UNITED STATES PATENT AND TRADEMARK OFFICE

APPLICATION NO.	FILING DATE	FIRST NAMED INVENTOR	ATTORNEY DOCKET NO.	CONFIRMATION NO.
09/530,156	08/31/2000	Oliver Hecker	AP9472	3844

Office Action Summary	Application No.	Applicant(s)
	09/530,156	HECKER ET AL.
Examiner	Art Unit	
Melody M. Burch	3683

DETAILED ACTION

FIG. 3

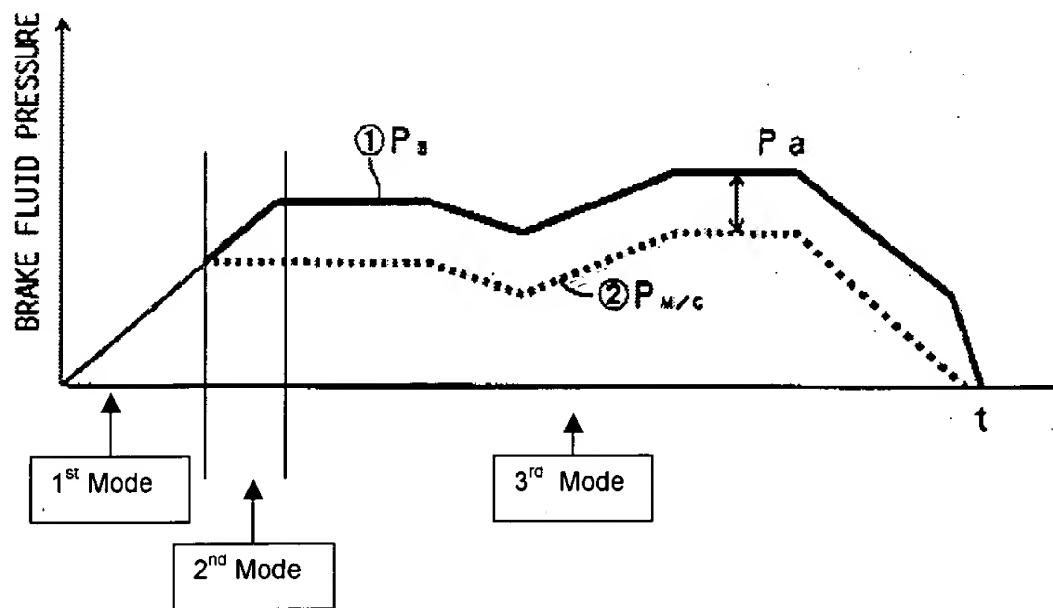
Re: claims 1, 10, 17, and 19. Nakanishi et al. Nakanishi et al. show in figure 3 a method of operating a brake assist system which comprises a first mode as labeled in the attached copy of figure 3 in which the brake assist system is not actuated, a second mode of operation as labeled in the attached copy of figure 3 in which after recognition of an emergency brake situation a pressure build-up of wheel brakes is generated, and a third mode of operation labeled in the attached copy of figure 3 which is provided for the transition from the second into the first mode of operation, comprising the steps of:

monitoring the wheel brake pressure in the third mode of operation as disclosed in col. 17 lines 63-65, determining when the monitored wheel brake pressure is excessively elevated compared to the tandem master cylinder pressure, and controlling the amount of excess elevation by functionally correlating the wheel brake pressure with the monitored master cylinder pressure throughout the duration of the third mode of operation as inferred in col. 17 line 66-col. 18 line 8.

Examiner notes that Nakanishi et al. show throughout the duration of the third mode as the controlling step further including the step of determining a momentary value of the wheel brake pressure by multiplying a momentary value of a time-dependent excess function with the momentary value of the master cylinder pressure. As discussed in the specification of the instant application $p_{wheel}(t) = K(t) * pmc(t)$ or $p_{wheel}(t) / pmc(t) = K(t)$. Examiner maintains that the ratio of $p_{wheel}(t) / pmc(t)$ is inherently shown throughout the duration of the third mode of operation in Nakanishi et al. since at each time in the graph there is a wheel brake pressure value and a master cylinder pressure value. Nakanishi et al. also show the limitation wherein the controlling step further includes keeping the excess elevation function constant in time intervals in which the master cylinder is increasing as shown in figure 3 in the portion of the third mode in the area of the encircled number 2.
